SUBJECT: ISSUANCE OF AMENDMENT NO. 93 TO FACILITY OPERATING LICENSE  
 NO. NPF-29 - GRAND GULF NUCLEAR STATION, UNIT 1 (TAC NO. M80590)

GRAND GULF NUCLEAR STATION, UNIT 1

ATTACHMENT TO LICENSE AMENDMENT NO. 93

SAFETY EVALUATION BY THE OFFICE OF NUCLEAR REACTOR REGULATION

FIGURE 3.2.3-1 MCPR<sub>f</sub>

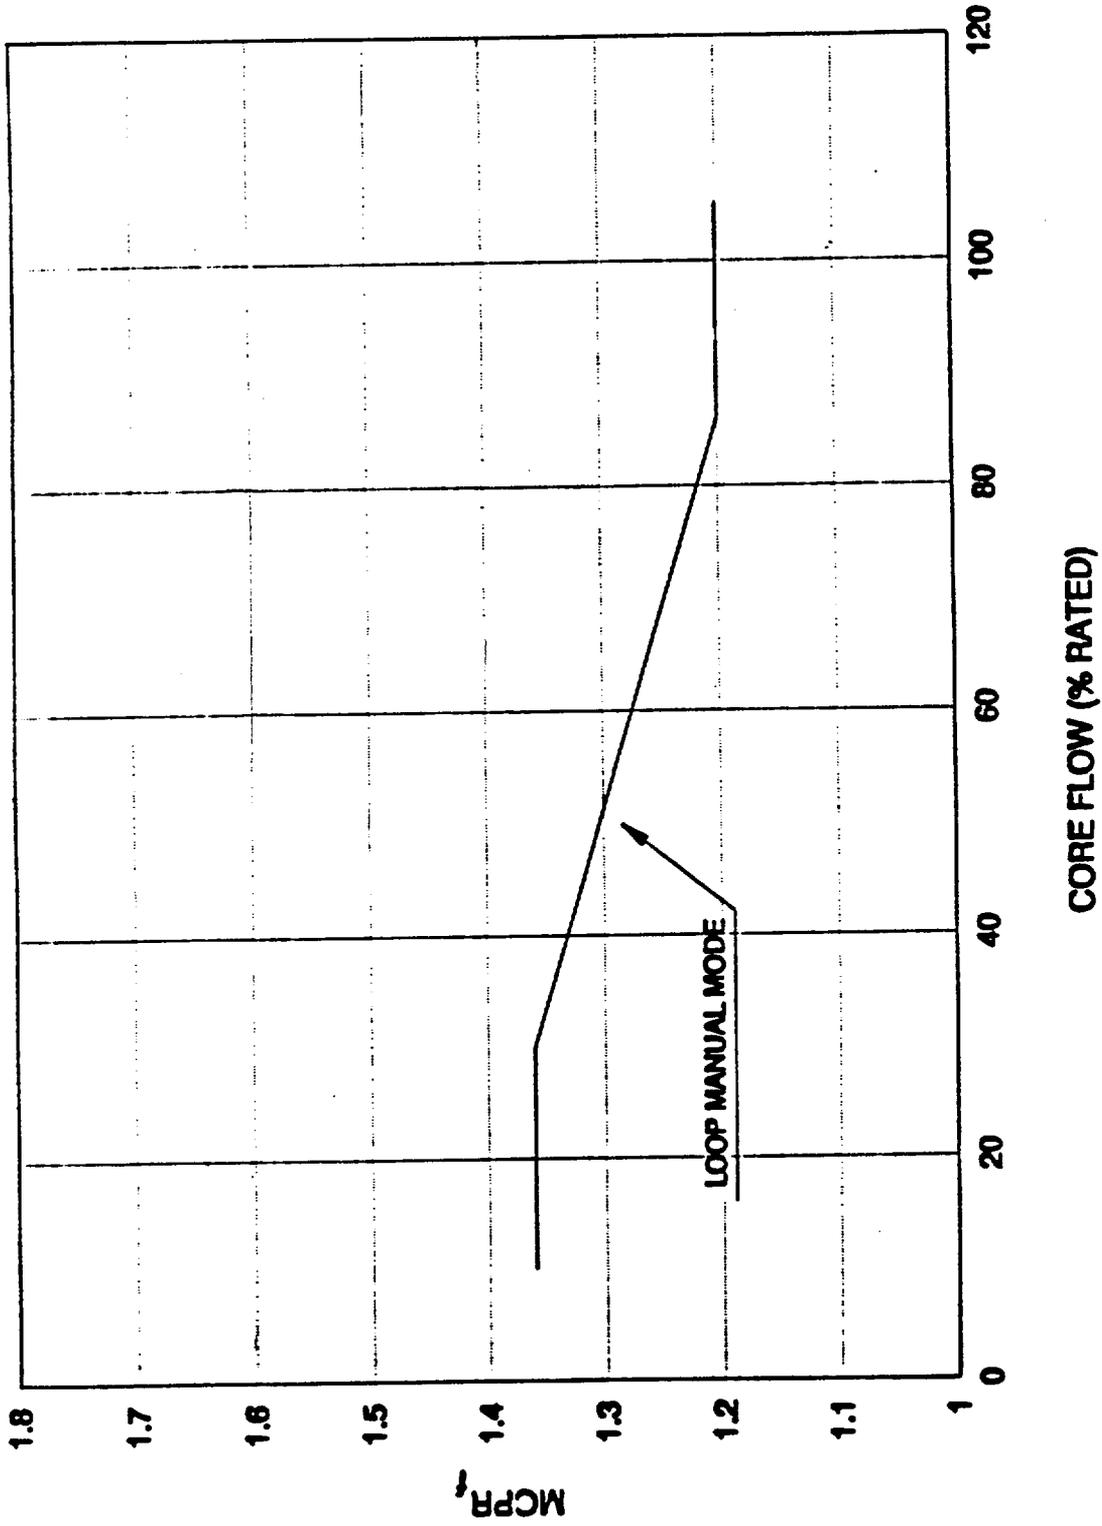
The amendment deletes references in the Technical Specifications to operation of the Reactor Recirculation System in the Non-Loop Manual (automatic) mode of flow control. This mode of operation was eliminated by a 10 CFR 50.59 evaluation and an approved design change implemented during Refueling Outage 4 in 1990.

There are no TS operating conditions or actions requiring the availability of the automatic mode of flow control. Both operating modes are unique and function independently of each other. The choice of operating in the automatic or manual modes is based on the preference of the operator. As this is a non-safety related system and with the automatic mode permanently disabled, references to and inferences from this mode are unnecessary and potentially misleading. The revisions to the TS remove these references and inferences and include removal of thermal operating limit curves strictly associated with the automatic mode of operation.
